STATION, RADIO, A13

TECHNICAL HANDBOOK - MISCELLANEOUS INSTRUCTION

TELECOMMUNICATIONS
F 149 Misc Instr No 2

Fig 1 - Temporary modification assembly

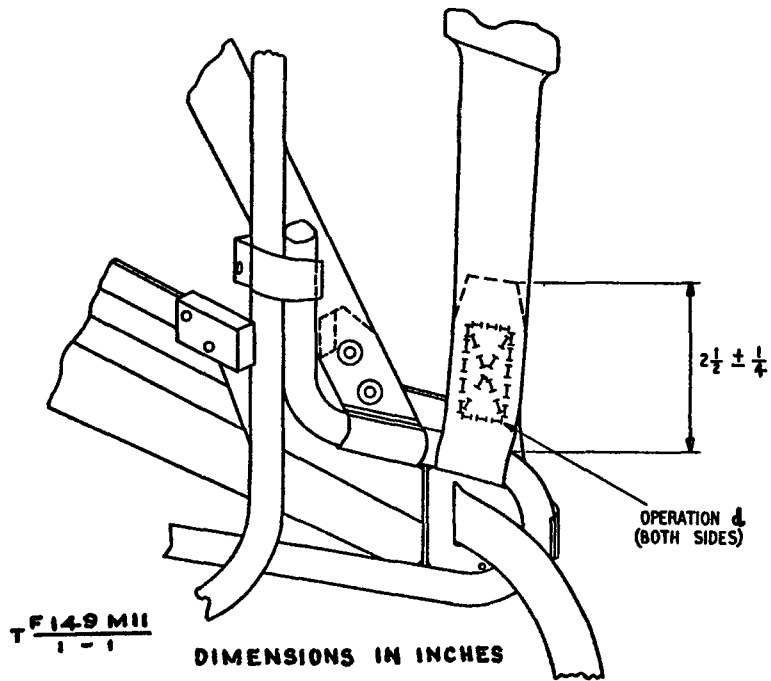
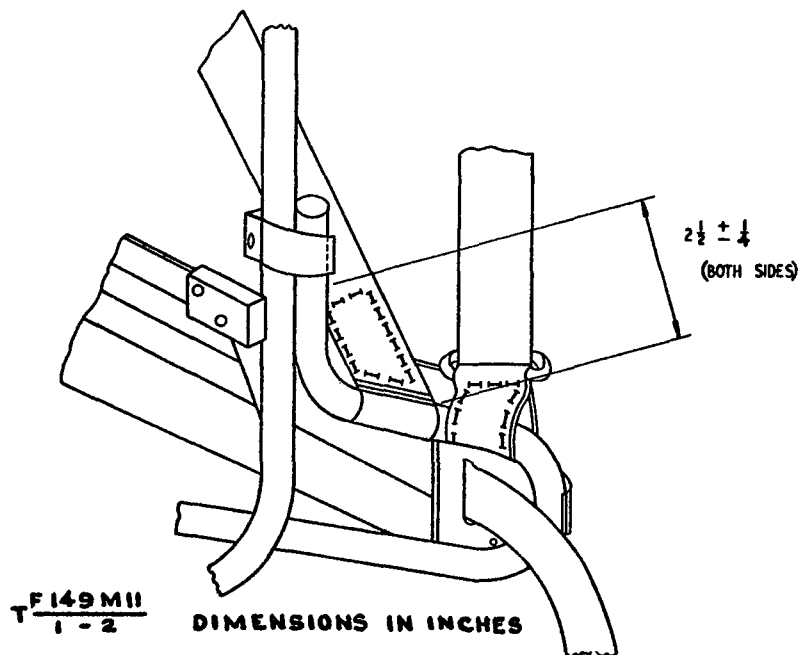
- a. Cases of the canvas shoulder straps breaking away from the carrying frame have been reported. This failure is due to the rusting of the four screws, holding the backrest to the frame, which rot the canvas between the backrest and frame.
- b. This instruction details the action to be taken as a temporary measure, in operational areas where high humidity is likely to cause this failure or where the failure has already occurred.
- c. It should be noted that carrying out this instruction causes the straps to become part of the frame whereas they are catalogued as part of the webbing. In current production, provision is made for the straps to be fitted in the same position as detailed below but removable from the frame (see Fig 2).

- a. Remove the four screws and washers securing the padded waist support to the frame assembly and retain for re-fitting.
- b. This action releases the ends of the buckled shoulder straps, (5340-99-103-7359) from between the waist support and the frame.
- c. Leaving the ends of the straps free, reverse operation (a) after applying a thin coat of varnish DEF 32 (H1/8010-99-943-3454) or similar to the screw threads.
- d. Wrap the end of the shoulder straps around the frame, positioned round the curved part of the frame in front of the welded plate, and secure by stitching using rotproofed thread, or by suitable rivets and washers, (see Fig 1).

Fig 1 - Board 16, modification

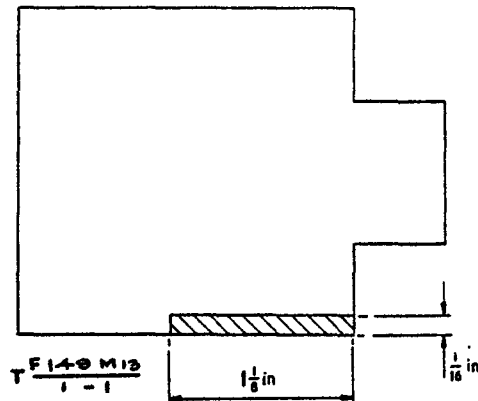
During production, under conditions of adverse tolerance build-up, instances have occurred of the panel, electronic circuit (5820-99-101-9807), board 16, fouling tagstrip TSC. This instruction details the procedure to be adopted when replacing panels on which this problem is encountered.

If it is found on replacement of board 16 that it fouls tagstrip TSC, refer to Fig 1 and remove the shaded area indicated. Apply a thin coat of varnish insulating (8010-99-943-3454) to the cut edges of the board.

Fig 1 - Location of screws

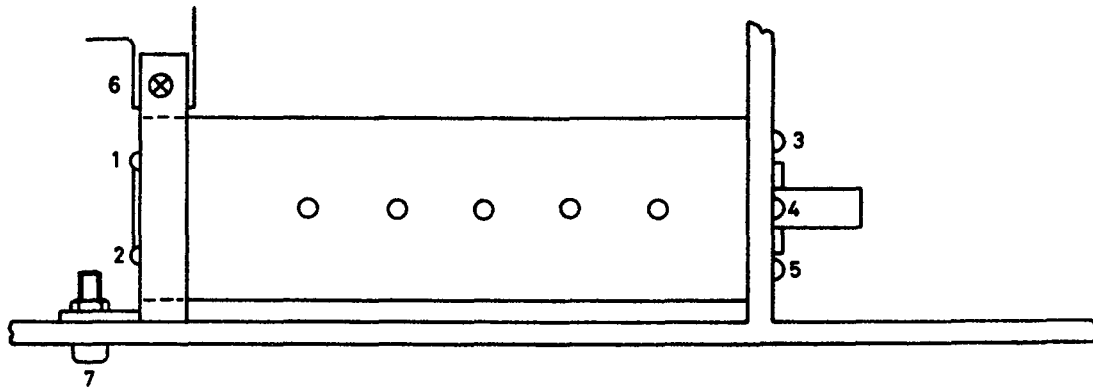
It has been found that the method of fitting a gang capacitor in an equipment can distort the vanes. This instruction details the action to be taken when replacing the main gang capacitor.

- a. Locate the rear mounting bracket on the gang capacitor and insert screws number 1 and 2 leaving them loose.
- b. Insert the gang capacitor into the front retaining hole and insert screws 3, 4 and 5 just taking up the slack. Ensure the gang is located correctly and tighten screws numbered 3, 4 and 5 sequentially.
- c. Insert screws numbered 6 and 7 leaving them loose.
- d. Lightly hold the rear mounting bracket simultaneously against the rear of the gang and the chassis at the positions of screws numbered 6 and 7 then tighten these screws.
- e. Finally tighten screws numbered 1 and 2.
